**SUBJECT: SSC 50N - STEERING RELAY ROD REPLACEMENT
CERTAIN 1989 – 1995 TRUCK 4WD, 1990 – 1995 4RUNNER 2WD AND 4WD, AND 1993 –
1998 T100 4WD VEHICLES (BOTH WITH AND WITHOUT POWER STEERING)**

In September, 2005, Toyota initiated a Special Service Campaign on the Steering Relay Rod of certain 1989 – 1995 Truck 4WD, 1990 – 1995 4Runner 2WD and 4WD, and 1993 – 1998 T100 4WD vehicles. This campaign initially omitted vehicles without Power Steering, however, based upon additional review by Toyota, it was determined that this omission was an error. Therefore, effective immediately, vehicles **without** Power Steering will be added to this campaign.

TECHNICAL INSTRUCTIONS

(Updated on October 24, 2005)

3. RECONNECT THE TIE RODS TO THE NEW RELAY ROD

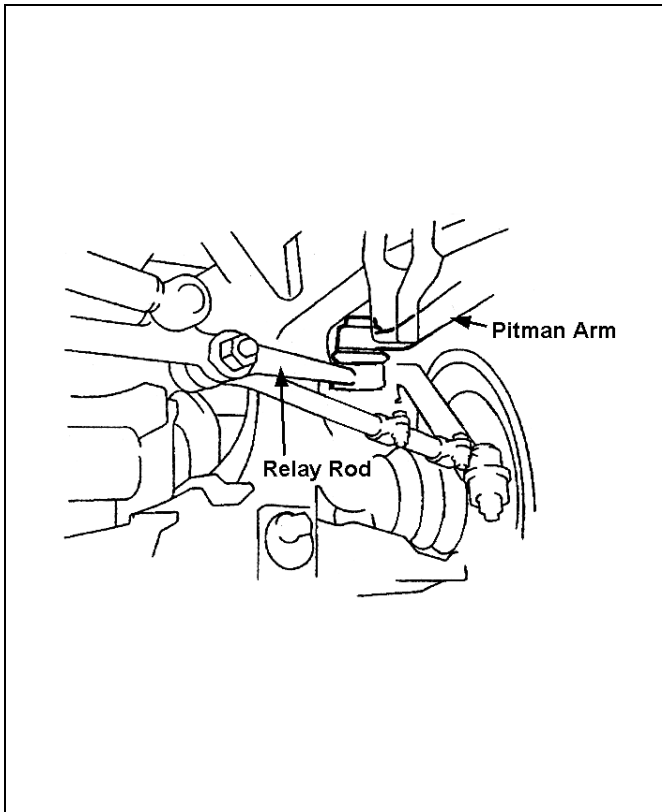
NOTE:

To prevent the over torque condition we have revised the torque specification.

Revised Torque Specification:
81 N·m (830 kgf·cm, 60 ft·lbf)

Maximum Torque Specification:
90 N·m (920 kgf·cm, 67 ft·lbf)
